10/720,729

<b>Office Action Summary</b>	<b>Application No.</b> 10/720,729	<b>Applicant(s)</b> RUTIGLIANO ET AL.	
	<b>Examiner</b> Charles E. Cooley	<b>Art Unit</b> 1723

## **NON-FINAL OFFICE ACTION AFTER RCE**

7. **Claims 13-17 and 19-20 are rejected under 35 U.S.C. 102(b) as being clearly anticipated by Calange (US 6,193,404 B1).**

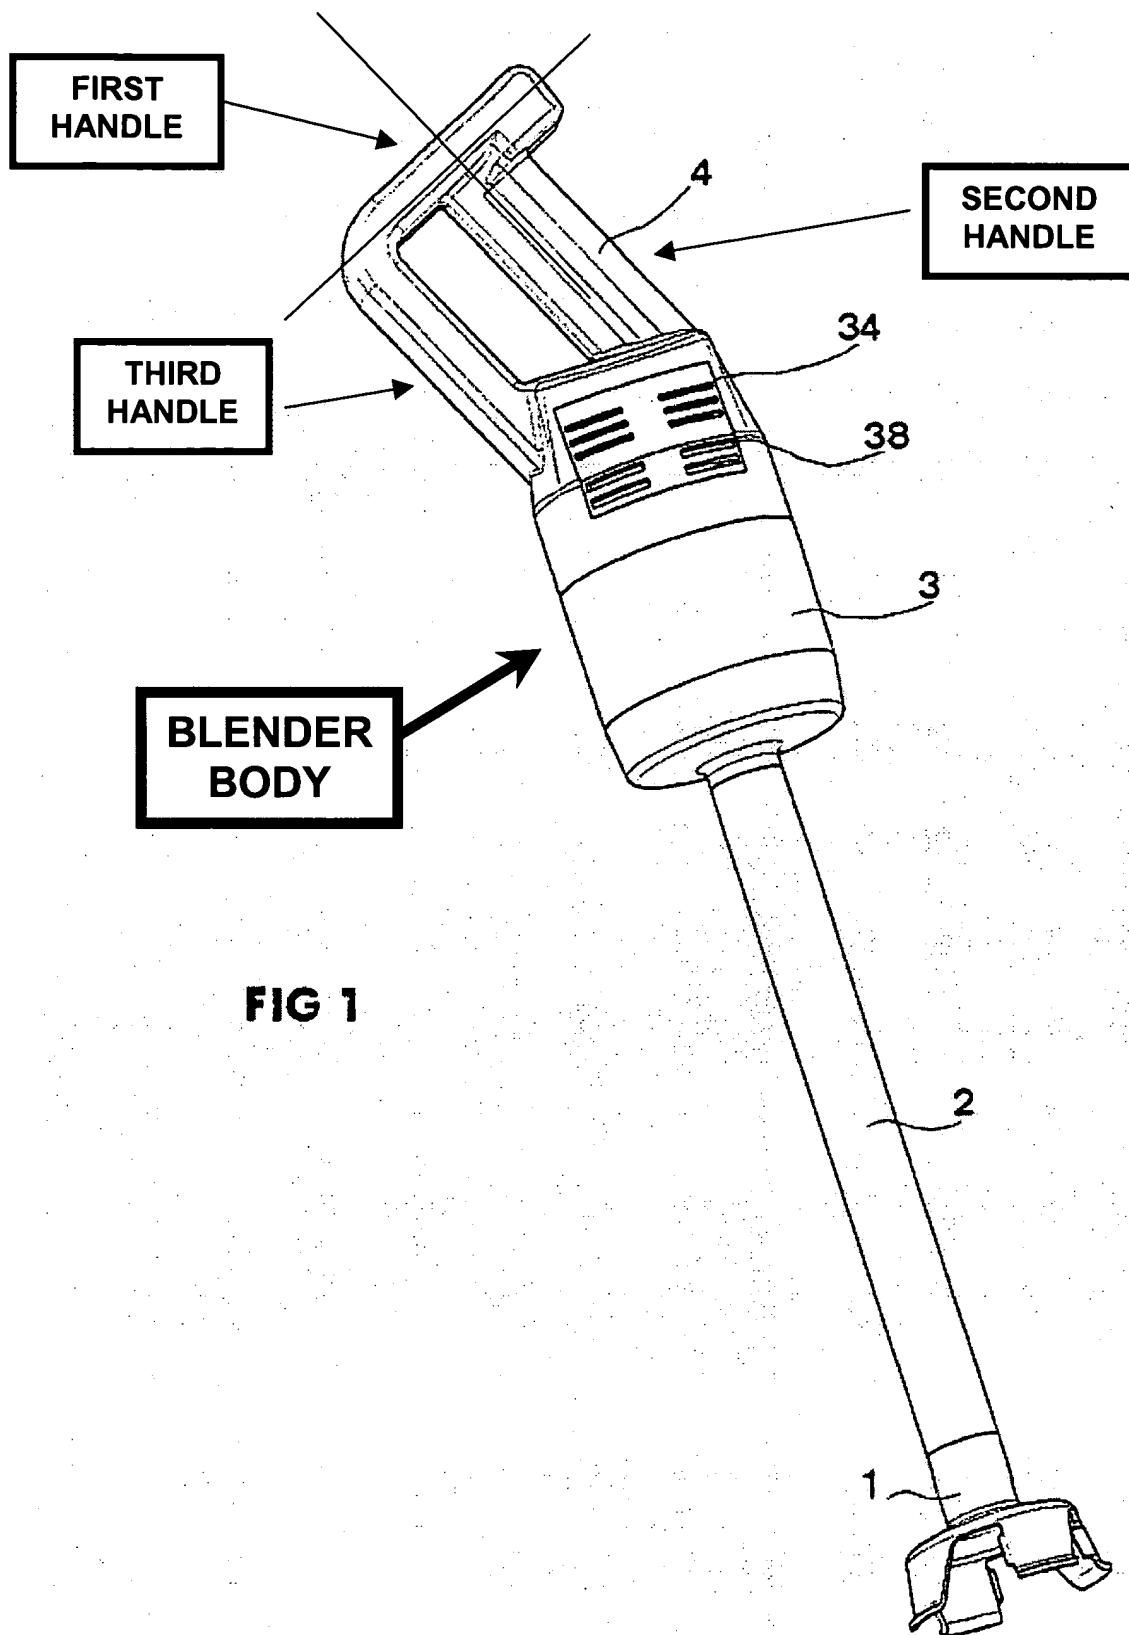
The patent to Calange clearly discloses a blender as seen below comprising a body (the housing seen in Fig. 1) for containing a drive motor 32, the body 3 having a shaped outer surface, an elongated first handle, an elongated second handle, and an elongated third handle as labeled below, the handles accommodating the palm of a user's hand; a drive shaft 5 operatively connected to said drive motor 32, and a tool 13

operatively connected to said drive shaft; wherein said first handle is elongated with a proximal end portion, a central portion and a distal end portion; wherein said proximal end and said distal end enable an operator's hand to easily grasp or wrap thereabout; a central portion of the top section of the first handle is connected to the second handle 4 (Fig. 1); wherein said second handle 4 can be handled by the operator to stabilize the immersion blender during operation; the first handle having a section disposed on a side of said body 3; the handles being capable of being disposed at any orientation with respect to a working surface; the third handle 3 is disposed on a side of the body (Fig. 1). As seen below, the first handle is disposed in a substantially perpendicular orientation with respect to the second handle and intersects the second handle at a center region thereof.

The examiner believes any part of a blending device that can be grasped by a user (such as elements denoted as handles, any projections from the motor housing, or an outer surface of the motor housing itself, etc.) can be considered a “handle” within the broad scope of the pending claims. Simply because an element has another function, there is no evidence that such an element could not be used or is wholly incapable of being implemented as a handle by an operator. With this not unreasonable approach, at least four handles can be identified on the device of Calange. Accordingly, with further regard to Calange, the multiple elements on the top of housing 3 can be considered discrete handles as pictured above, contrary to Applicant’s assertion.
